**Consumers  
Power  
Company**

DOCKET 50-255 - LICENSE DPR-20 -  
PALISADES PLANT - RESPONSE TO  
IE INSPECTION REPORT 80-02

PENETRATION NO. 48 - CONTAINMENT PRESSURE INSTRUMENTATION  
EXISTING

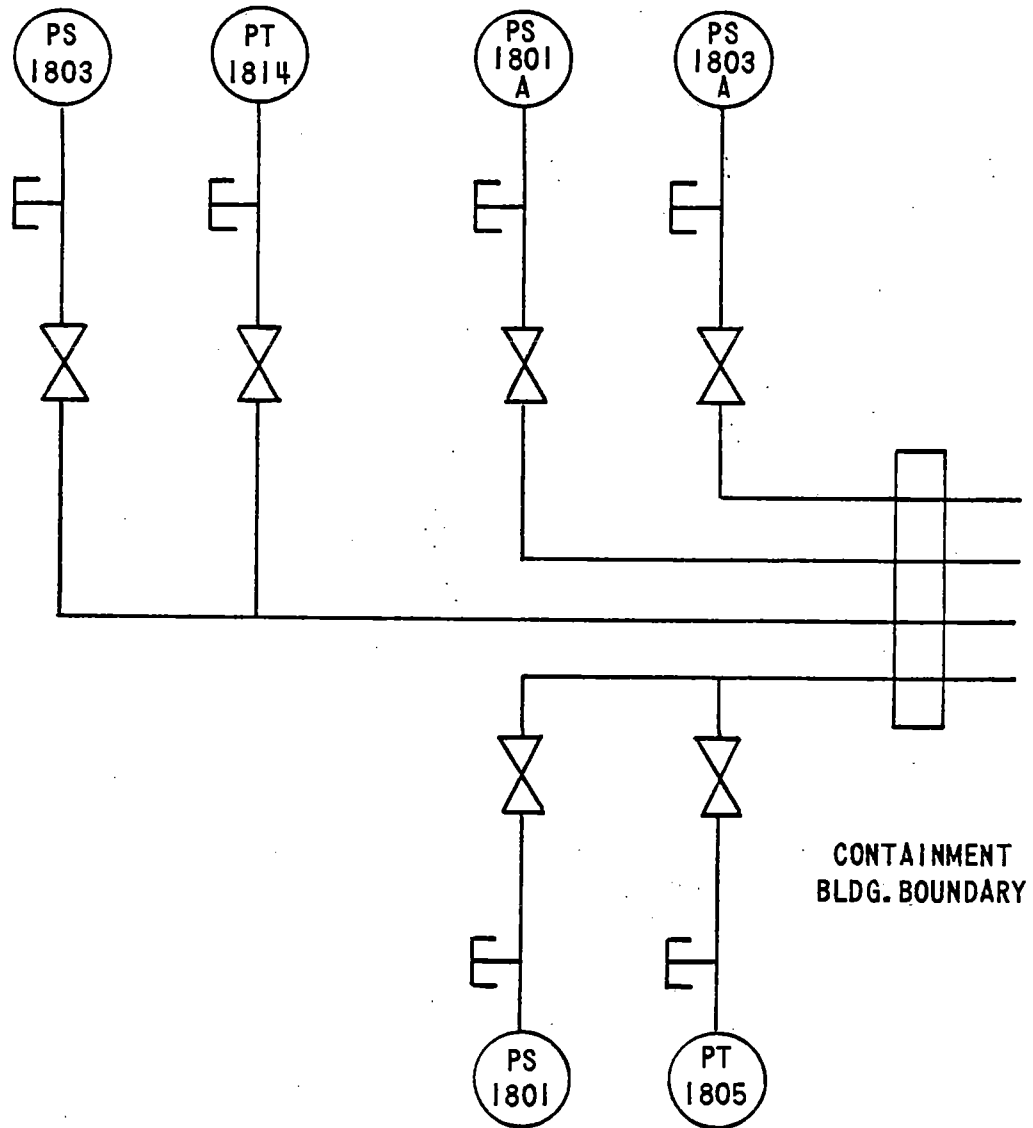
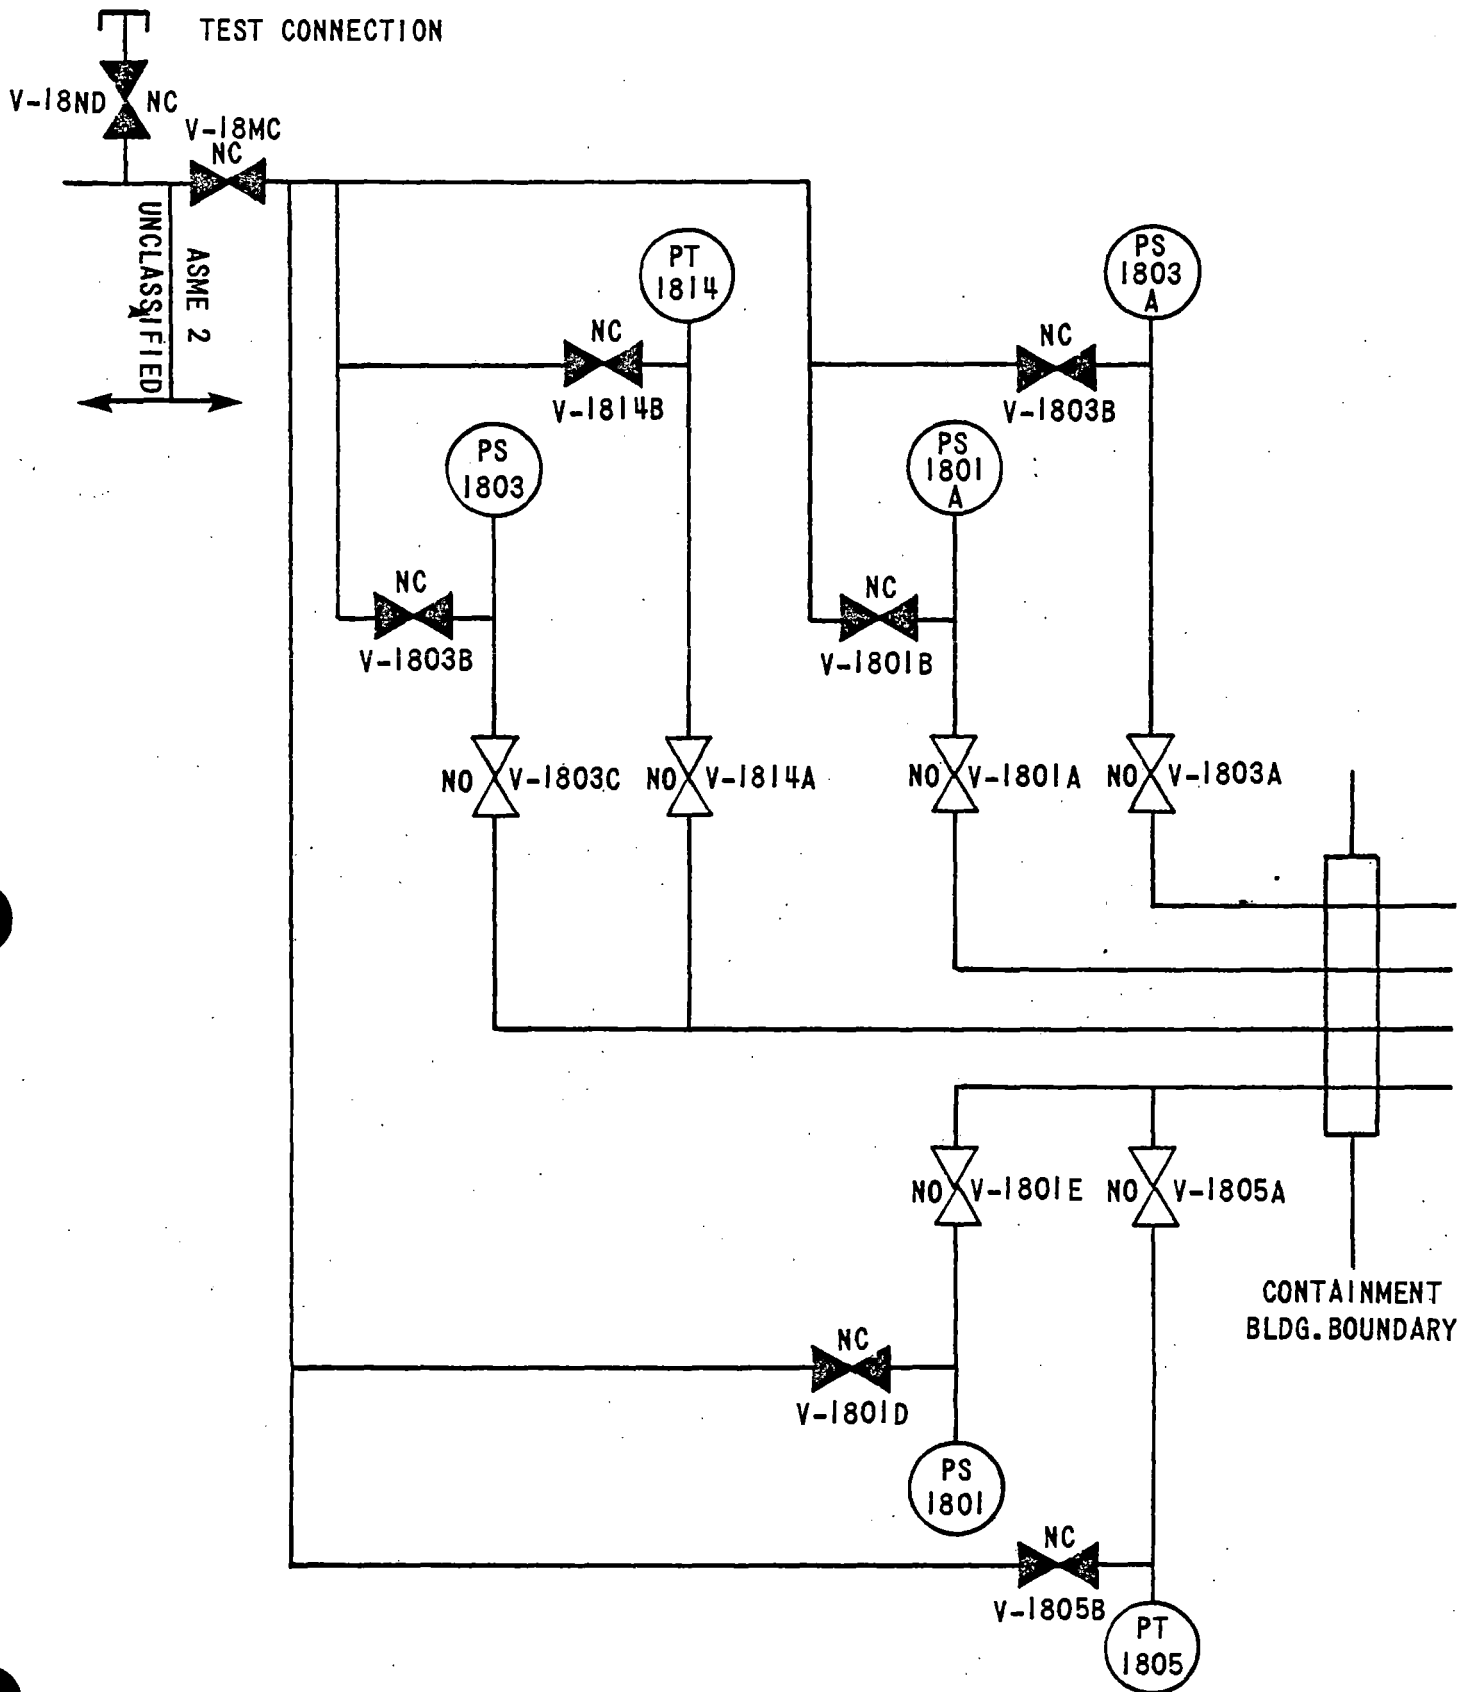
10 CFR 50, Appendix J, Section IV.A requires, in part "...replacement of a component which is part of the primary reactor containment boundary,...shall be followed by a Type A, Type B, or Type C test, as applicable...."

Contrary to the above, the licensee periodically removes a pipe cap on the containment pressure instrument lines to test and calibrate the pressure transmitters and switches. Although the pipe cap is part of the primary containment boundary, no leak test was performed after replacement of the cap following instrument testing on June 5 and on July 2, 1979. The reactor was operated at power after both tests.

Corrective Action Taken To Avoid Further Noncompliance - Figure 1 (attachment) illustrates the penetration of the containment pressure instrumentation as it existed during the subject inspection. The procedure used to calibrate this

instrumentation didn't require leak testing the cap on the instrument line upon completion of the calibration.

To avoid further noncompliance, the existing instrument lines are being modified as shown in Figure 2 (attachment). This modification will be completed prior to start-up. The new instrument line system provides double isolation (Valves V-18MC and V-18MD normally closed) prior to the test connection cap. This eliminates the cap from the containment pressure boundary system and the need for any type of leak test upon completion of calibrating the pressure transmitters. The subject procedure (RI-6) has been revised to accommodate these changes and will be implemented prior to start-up.

Date When Full Compliance Will Be Achieved - As stated above, the instrument line modification will be completed prior to start-up and the procedure implementation will be prior to start-up.
